From: [Ward, David \(CONTR\)](#)
To: [Sprenng - CDPHE, Carl](#)
Subject: RE: DRAFT RFLMA CR 2014-08 Provide flexibility to the flow configuration at the Solar Ponds Plume Treatment System (SPPTS) as part of the ongoing optimization effort.
Date: Thursday, July 10, 2014 2:31:00 PM
Attachments: [DRAFT RFLMA CR 2014-08 preapproval. jle.docx](#)

REGULATORY CONTACT RECORD 2014-08

Purpose: Provide flexibility to the flow configuration at the Solar Ponds Plume Treatment System (SPPTS) as part of the ongoing optimization effort.

Figure 1. Location of Excavation for Piping Installation

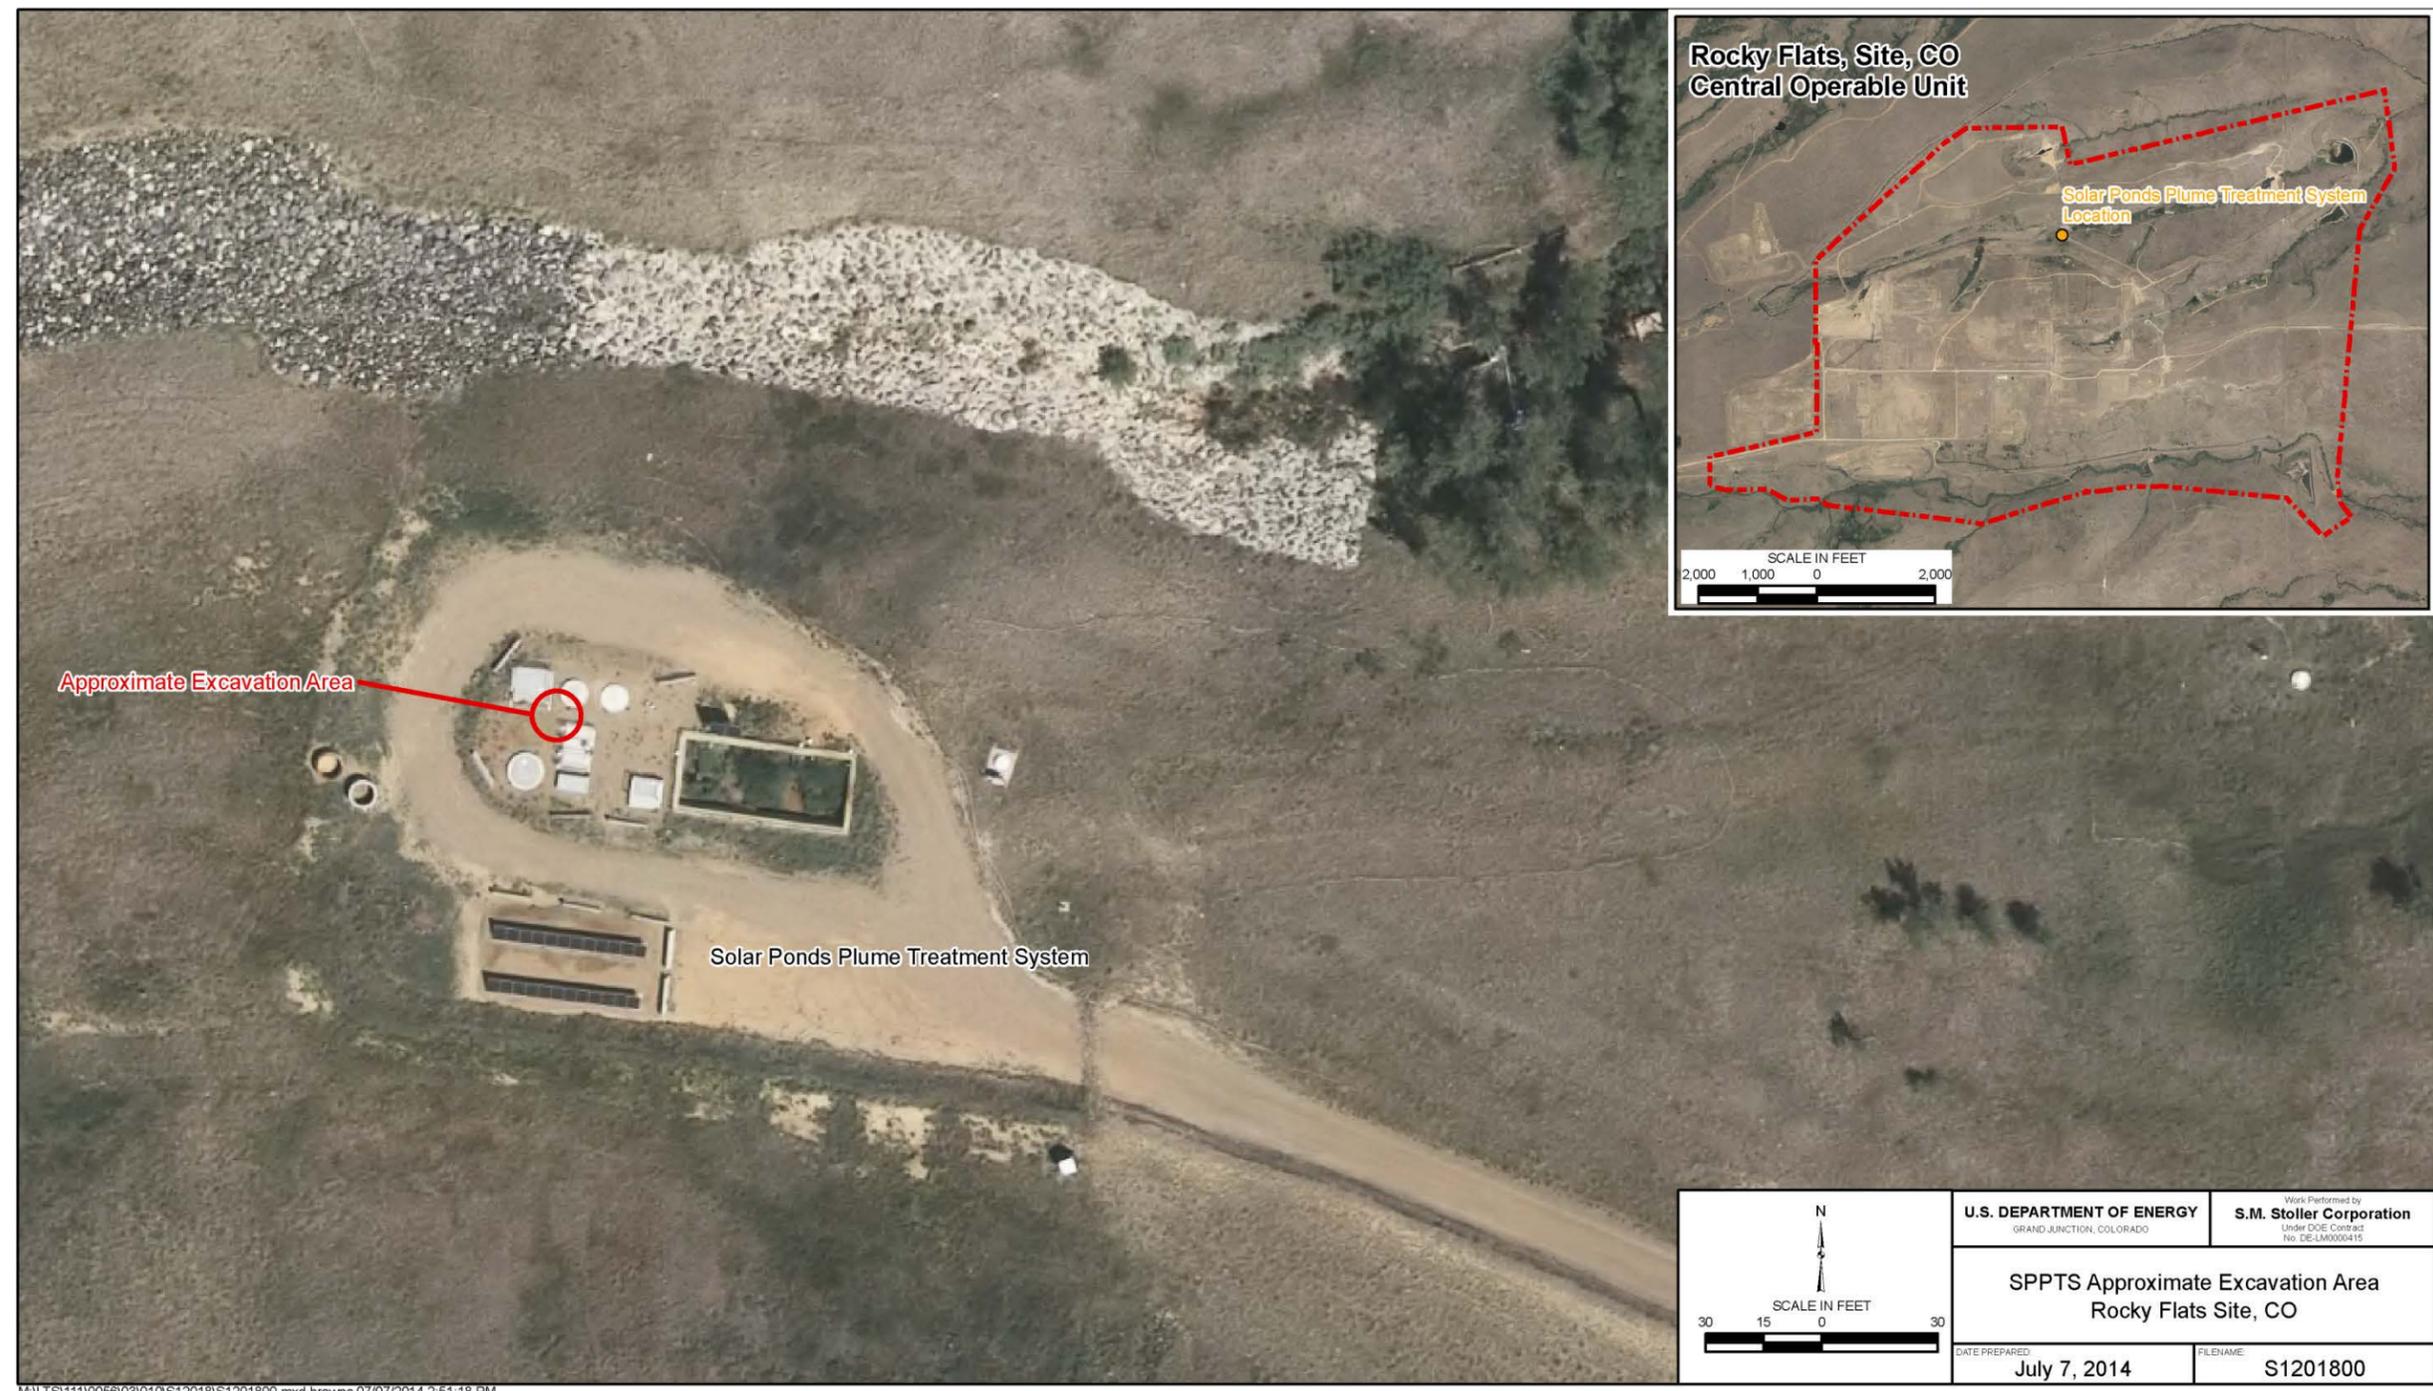
Looks good to me. You might consider adding, "A hole approximately 8 feet × 8 feet and 6 feet deep will be excavated" to the Soil Disturbance Review Plan item #1. It's stated in the CR, but would be appropriate to repeat it here to fully describe the extent of the project.

A hole approximately 8 feet x 8 feet and 6 feet deep will be excavated to access the existing piping that requires modification to provide the needed flexibility. Figure 1 in Contact Record 2014-08 shows the location of the excavation and soil disturbance. This excavation is within the existing footprint and fill materials of the Phase II and Phase III upgrades to the SPPTS.
